REV. A -- ADDENDUM #1 Date: 3/21/12	 <p style="text-align: center;">Tennessee Valley Healthcare System</p> 	 <p> Approved: -- Approved: -- </p>	Drawing Title GROUND FLOOR PLAN- ELECTRICAL Approved: Facility Manager Approved: Director	Project Title REPLACE ATTIC AHU'S- BLDG 6 Building Number: 6 Location: VAMC - MURFREESBORO	Date: 03/21/2012 Project No.: 626A4-11-204 Drawing No.: 6-E4 File Name: --
--	---	---	---	---	--

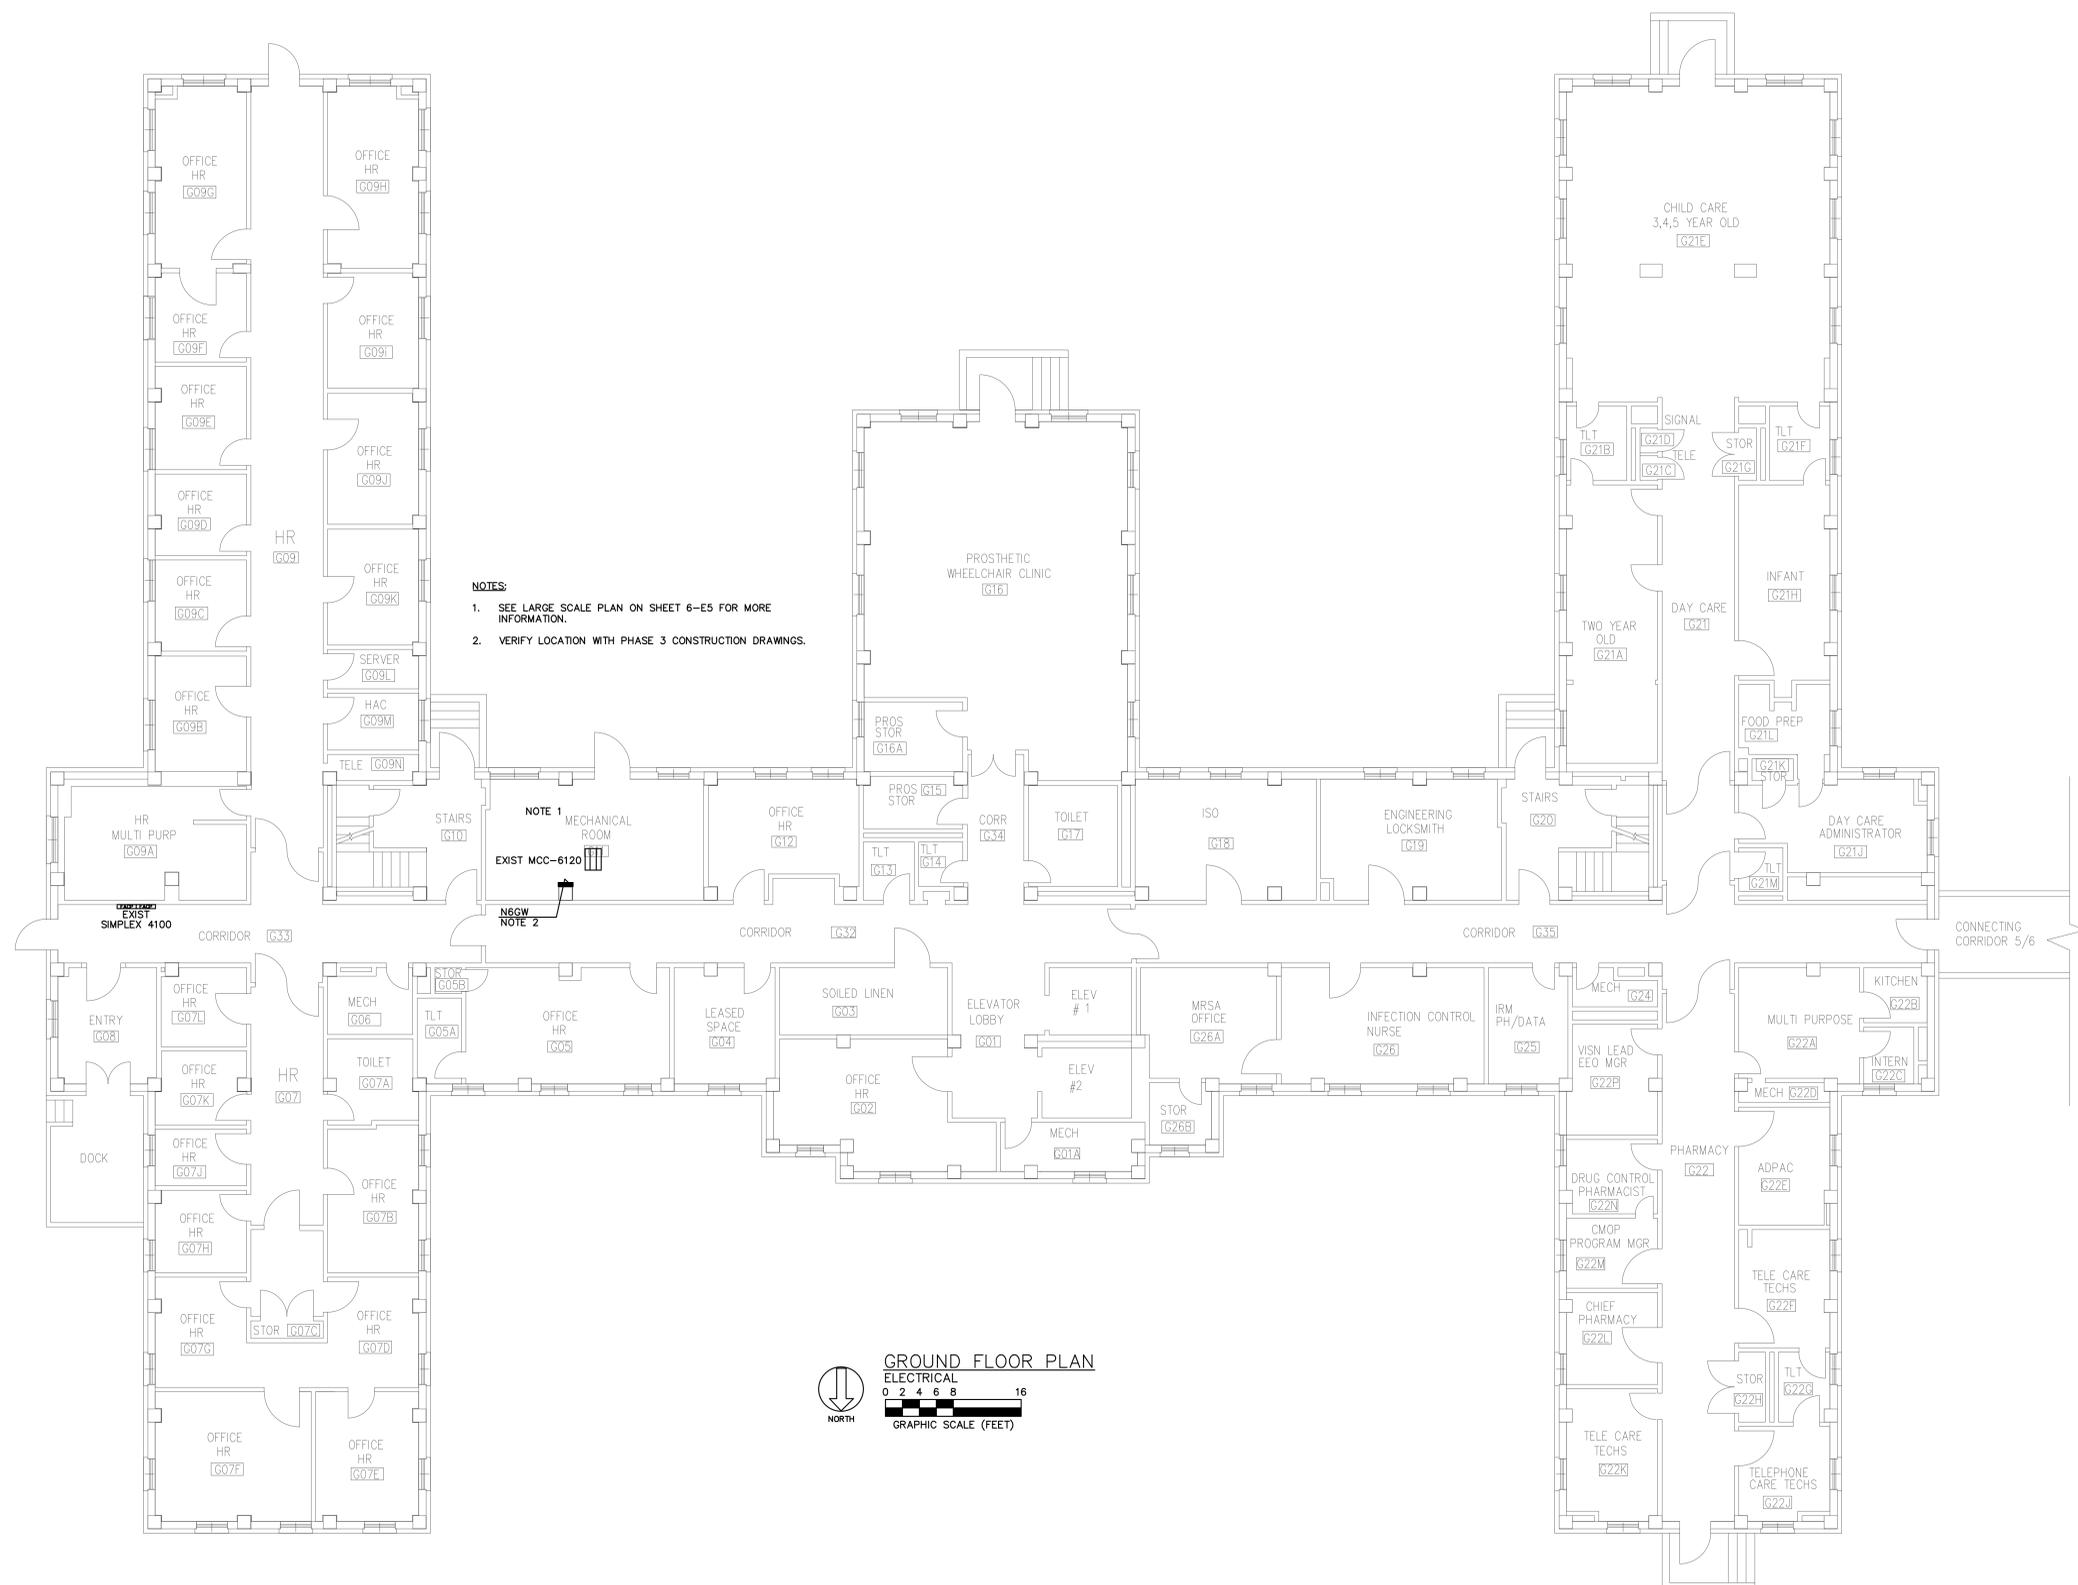
NOTE 1
 MECHANICAL ROOM
 EXIST MCC-6120
NOTE 2
 NEW
